Access Compliance Report

Public Rights-of-Way

Intersection ID: 10035790	Main Street: REMOUNT_RD	Cross Street: N/A	Location: SW
ADA ID: 5D402E233C1A	Ramp Type: BlendTrans1	Initial Pass/Fail: Fail	Overall Compliance: No
		Severity Score: 25

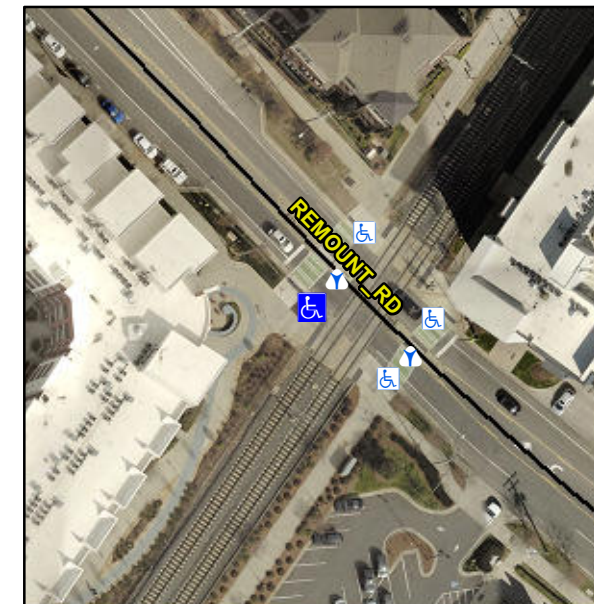
Compliance	Description	Data	Compliance	Description	Data
N/A	Ramp Length (in)	131.0	Yes	BlendTrans Slope (%)	2.7
Yes	Ramp Width (in)	142.0	No	BlendTrans XSlope (%)	8.6
N/A	Flare Type LT	N/A	N/A	Flare Type RT	N/A
N/A	Flare Slope LT (%)	N/A	N/A	Flare Slope RT (%)	N/A
N/A	Flare Traversable LT?	N/A	N/A	Flare Traversable RT?	N/A
N/A	Landing Length (in)	N/A	N/A	DWS Provided?	N/A
N/A	Landing Width (in)	N/A	N/A	DWS Contrast?	N/A
N/A	Landing Slope (%)	N/A	N/A	DWS Length (in)	N/A
N/A	Landing X Slope (%)	N/A	N/A	DWS Full Width?	N/A
N/A	Landing Curb? (Y/N)	N/A	N/A	DWS Offset (in)	N/A
N/A	Shared Landing?	N/A			
N/A	Gutter Ponding?	N/A	N/A	Gutter Slope (%)	N/A
N/A	Gutter Lip Ht (in)	N/A	N/A	Gutter X Slope (%)	N/A
N/A	Painted X Walk1?	Yes	N/A	Painted X Walk2?	N/A
	X Walk 1 Direction	To NE		X Walk 2 Direction	N/A
	X Walk 1 Width (in)	135.0		X Walk 2 Width (in)	N/A
	X Walk 1 Slope (%)	1.4		X Walk 2 Slope (%)	N/A
	X Walk 1 X Slope (%)	0.7		X Walk 2 X Slope (%)	N/A

Remove & Replace Curb Ramp With Two New Directional Ramps or Equivalent.

R304.5.3
